Response to Additional Submissions | STACK SYD01 Data Centre, Erskine Park (SSD-82211208)

This letter has been prepared by Urbis Ltd on behalf of STACK Infrastructure in response to additional comments received in relation to the proposed STACK SYD01 Data Centre at 78 Lockwood Road, Erskine Park (SSD-82211208) and the associated Amendment package.

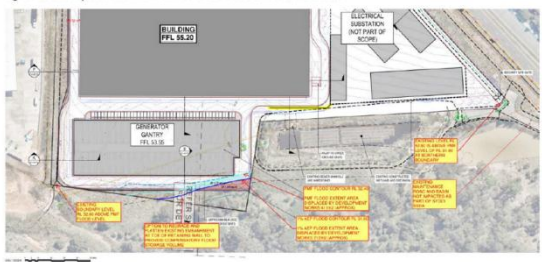
3. Minor Matters for consideration	
Flood Impact Risk Assessment	
The location of the diesel generator gantry in the Flood Impact Risk Assessment indicates a potential flood contour close to the location of the generators (and presumably, chemical storage). In the event of a loss of containment, escaped diesel is likely to follow the same flood contour as a pollution corridor into the neighbouring environment.	The concern raised is based on existing flood contours shown in Figure 4 of the FIRA, which reflect the site's existing topography prior to the implementation of the proposed civil works. The development includes a perimeter retaining wall along the outside edge of the circulation roadway which provides physical protection

between the flood affected area and the generator and diesel storage areas. The retaining wall has a design crest level of RL 53.30, compared with the assessed 1% AEP and PMF flood levels of RL 51.60 and RL 52.40 respectively. This provides approximately 1.7 metres of freeboard above the 1% AEP flood level, and 0.9 metres of freeboard above the PMF level, consistent with the requirements of the Flood Impact and Risk Assessment: Flood Risk Management Guideline LU01.

Accordingly, floodwaters would not be able to encroach into the site beyond the proposed perimeter retaining wall and would not create a pathway for off-site transport of pollutants from the generator and fuel storage areas.
